CONTRACT CHANGE ORDER NO. 231
SHEET 2 OF 4

SAN FRANCISCO OAKLAND BAY BRIDGE
EAST SPAN SEISMIC SAFETY PROJECT
SELF-ANCHORED SUSPENSION BRIDGE
(SUPERSTRUCTURE & TOWER)

RAILING LAYOUT NO. 3

EMERGENCY ACCESS DETAIL
1:20

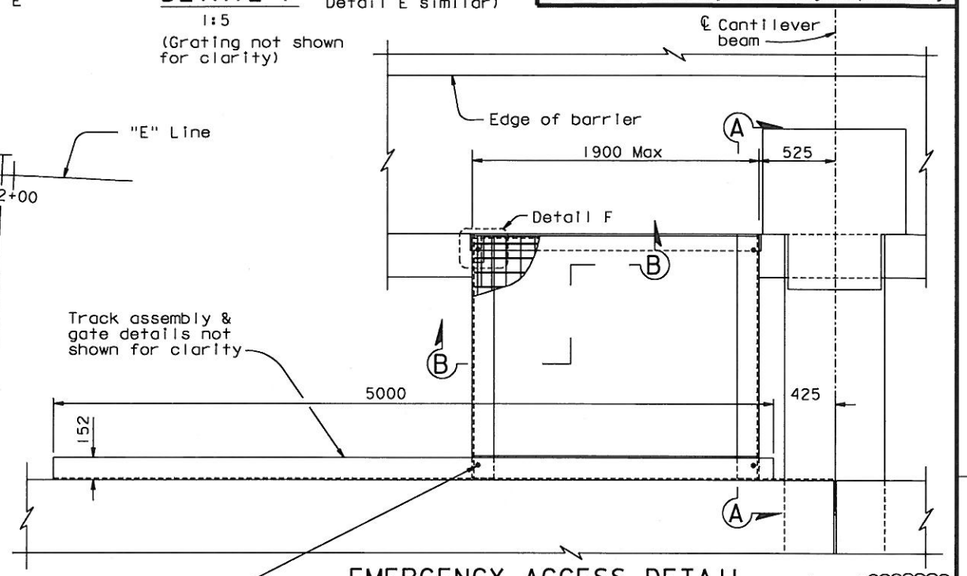
MARK	DATE	DESCRIPTIONS	BY	CH'D	CCO#
5	01/27/12	EMERGENCY ACCESS RAILING MODIFICATIONS	HT	TH	231
4	11/12/10	BIKEPATH HANDRAIL MODIFICATIONS	TH	JD	169
3	08/20/10	BIKEPATH DETAILS	TH	MN	99
2	11/26/08	BIKEPATH DETAILS	TH	MN	99
1	09/07/07	MECHANICAL MODIFICATIONS	JD	TH	31

DETAIL G
1:20
(EMERGENCY ACCESS RAMP AT PP 123)

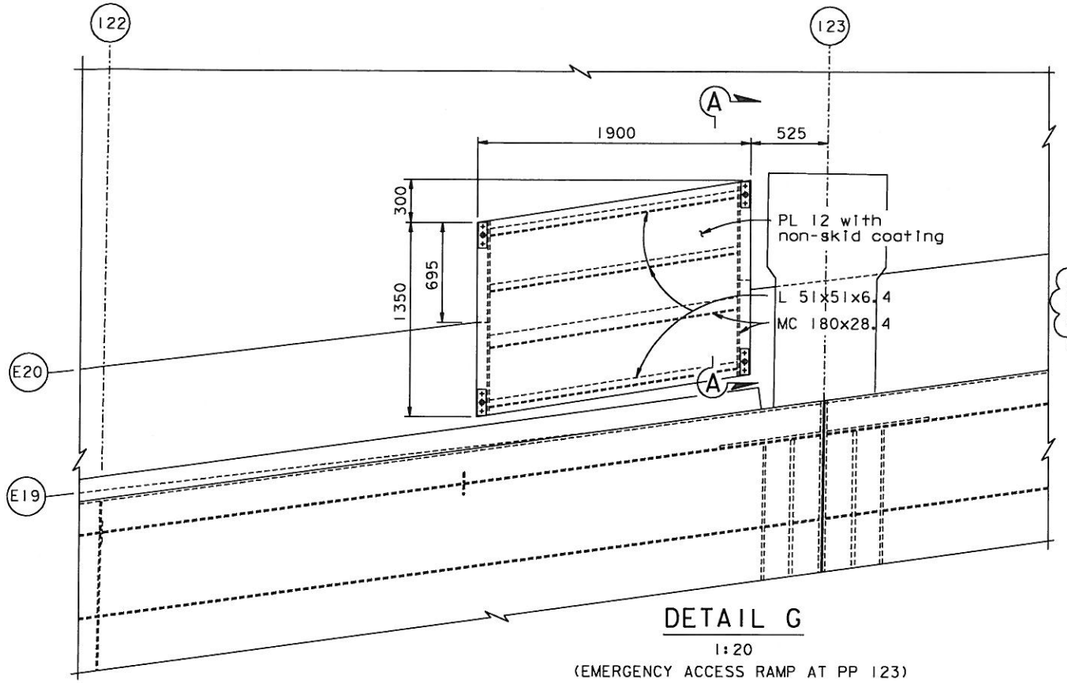
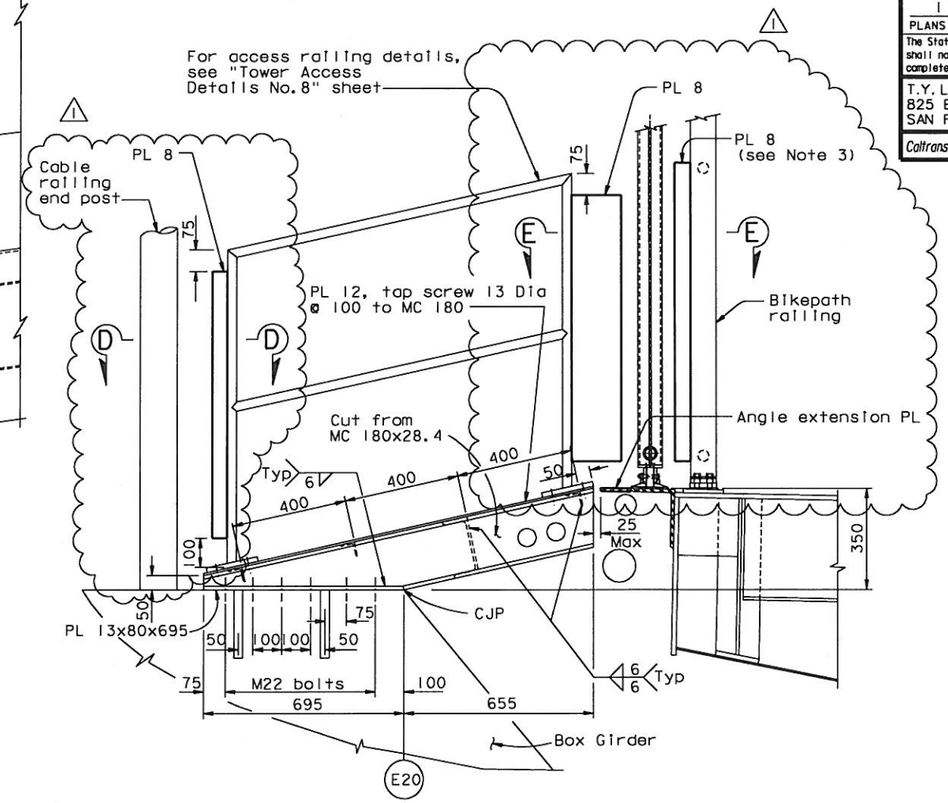
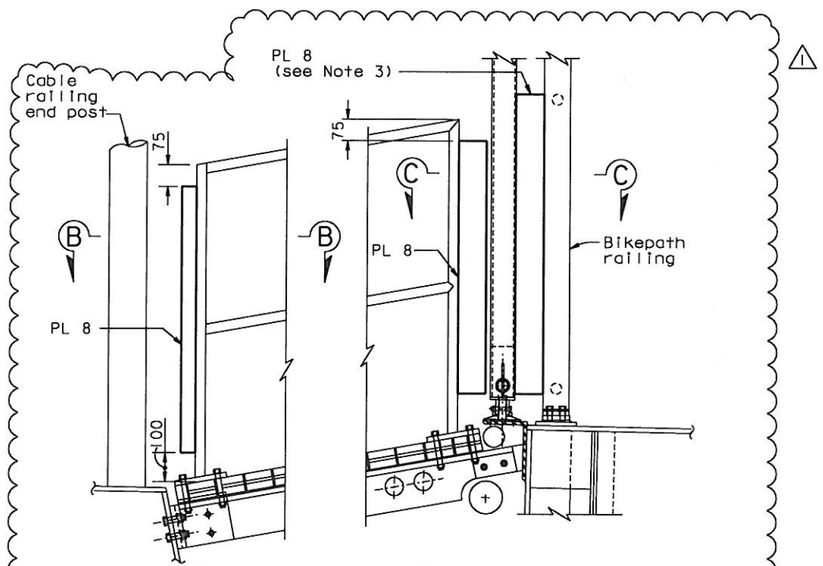
MARK	DATE	DESCRIPTIONS	BY	CH'D	CCO#
1	01/27/12	EMERGENCY ACCESS RAILING MODIFICATIONS	HT	TH	231
0	11/26/08	BIKEPATH DETAILS	TH	MN	99

1. For details not shown, see "Railing Layout No. 3" sheet.
2. For Sections B-B, C-C, D-D and E-E, see "Railing Layout No. 3B" sheet.
3. The top of PL 8 on bikepath railing post shall align with the top of upper 38 Dia pipe. The bottom of PL 8 on bikepath railing post shall align with the bottom of lower 38 Dia pipe.
4. Finish paint all PL 8 and angle extension PL.

RAILING LAYOUT NO. 3B

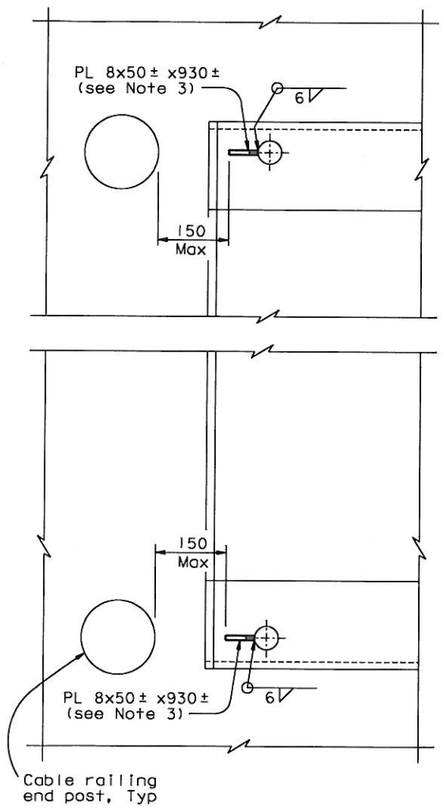
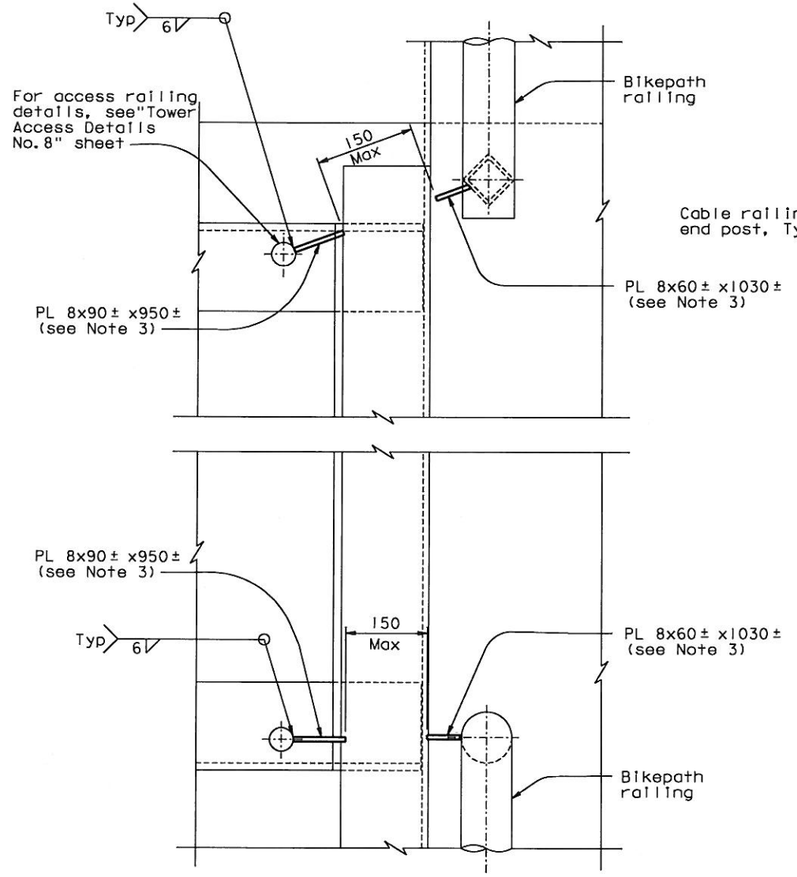
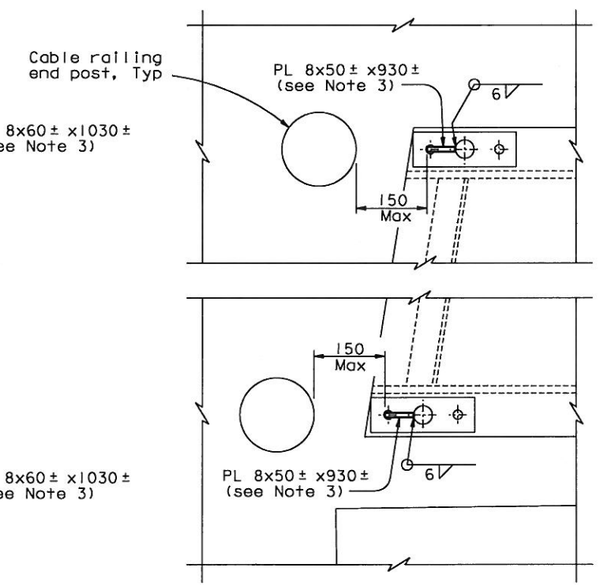
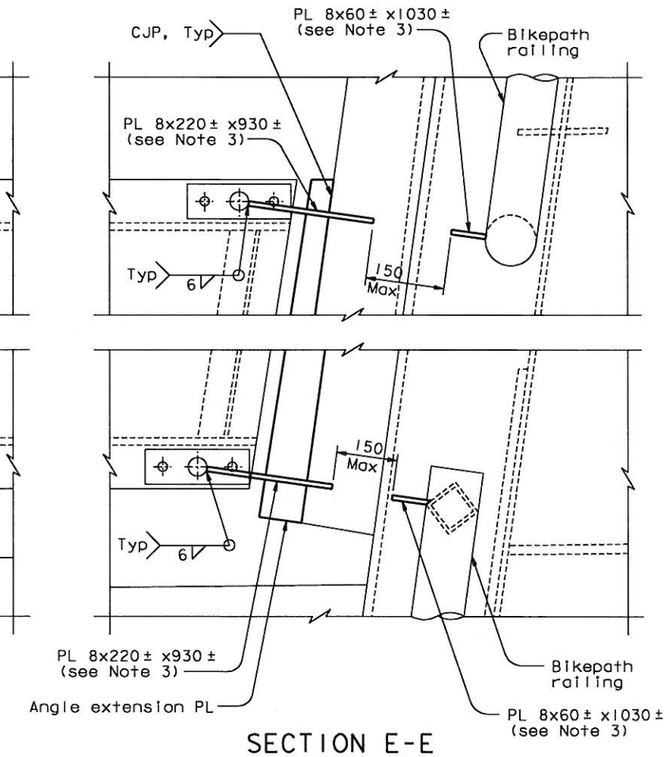
MARK	DATE	DESCRIPTIONS	BY	CH'D	CCO#
0	01/27/12	EMERGENCY ACCESS RAILING MODIFICATIONS	HT	JD	231

1. For details not shown, see "Railing Layout No. 3" sheet.
2. PL 8 edges shall be ground smooth.
3. Dimensions of PL 8 shall be adjusted to achieve a gap of 150 Max.
